## **SAFETY RECALL CAMPAIGN 2A89** **UH200A CVT Driven Face Replacement**

**Affected Models:** 2018 - 2019 UH200A (Burgman 200)

*Issued by Suzuki Motor of America, Inc., on May 9, 2019*

**CVT MOVABLE DRIVEN FACE**

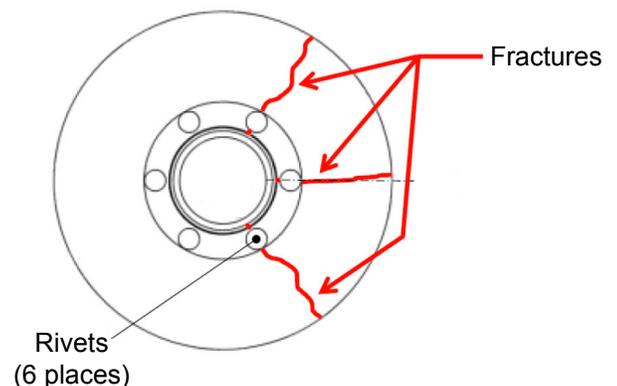
The holes for the rivets that fasten the component parts of the continuously variable transmission (CVT) movable driven face have a shape that may cause the rivet connections to be insufficient. Continued use of the scooter with this condition may allow excessive stress to be applied to the rivet connections when accelerating, and the movable driven face of the CVT may break while riding. If the movable driven face of the CVT breaks while riding, the scooter will become disabled, increasing the risk of a crash.

Install a replacement CVT driven face set as outlined in this Technical Service Bulletin, and submit a warranty claim for reimbursement.

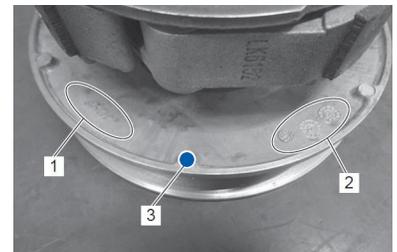
Current  
Driven Face Set  
**NO** blue paint  
between the two  
casting impressions  
(1 and 2)

Countermeasure  
Driven Face Set  
**Blue paint (3)** placed  
between the two casting  
impressions (1 and 2)
